To: Eastleigh Borough Council

9th June 2023

Reference Planning Application H/23/95227 - 10 Drummond Way

Illustration overlaying a typical car wheel swept path on to the proposed site layout plan.

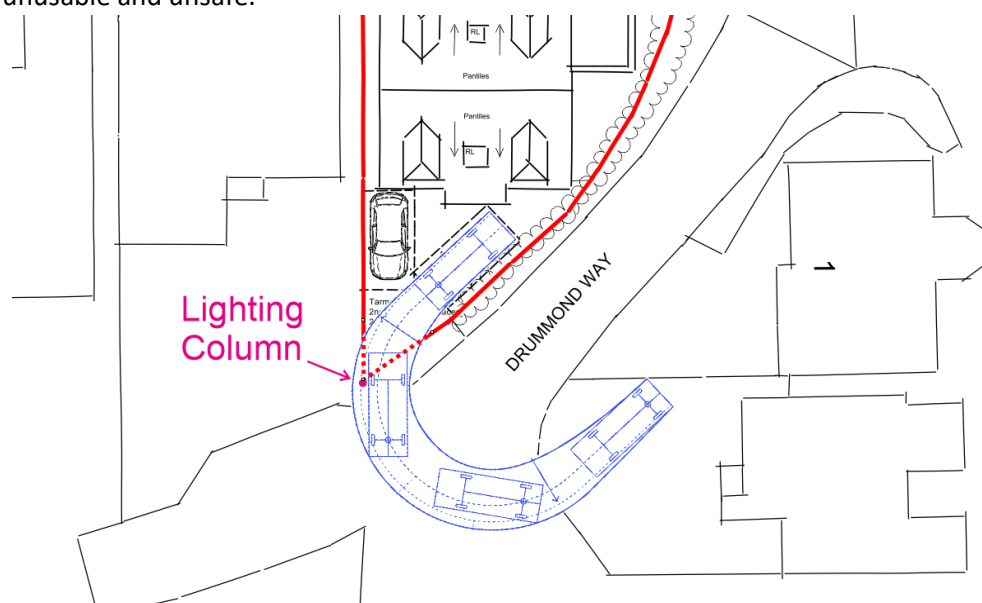
There are illustrations within the application showing two cars parked side by side, as opposed to the previous tandem parking submission which overlapped the property boundary. We question the accuracy of the proposed parking arrangements. On one hand the applicant states in the Design and Access Statement summary that *"the existing garage measures 2.39 x 4.78m internally. It is not possible to use this to park a car and it is significantly smaller than the minimum size given in the EBC residential car parking standards document"* but then shows two car parking bays on the driveway using the 2.4 x 4.8m dimensions. So, in reality it is possible to accommodate a car in the existing garage and this could have been utilised as part of the design planning and/or that the dimensions being used to show the driveway parking spaces are incorrect (too small). Notwithstanding this contradictory observation, we question that it is even possible to accommodate properly and safely two useable side by side parking spaces on the awkward triangular driveway.

Whilst the planning illustrations used are sketchy in some respects and not necessarily accurate, allowing for the frontage roofline and new porch area (now extended further in the middle of the property/driveway) - the suggested configuration of the two parking spaces are such that primary pedestrian access and disabled access would be difficult, if not impossible. As a wheelchair user for example would have difficulty in getting between the two parked vehicles to enter or leave the house given their close proximity. Similarly, given the location of the spaces to the boundaries, it is difficult to imagine how a driver or passenger could gain access, or indeed leave a vehicle, being that the doors would be hard up against a solid boundary. Boundaries that would require entering/overlapping onto council highways, utilities land and/or a neighbour's front garden.

Whilst we are not experts, it is not difficult to demonstrate that the oblique parking space proposed, in combination with the cramped nature of the front drive proposed, the proximity of a street lighting column on the boundary line (within the swept path) and the narrow width of the road itself results in substantial vehicle overruns, effectively making the space unusable and unsafe.
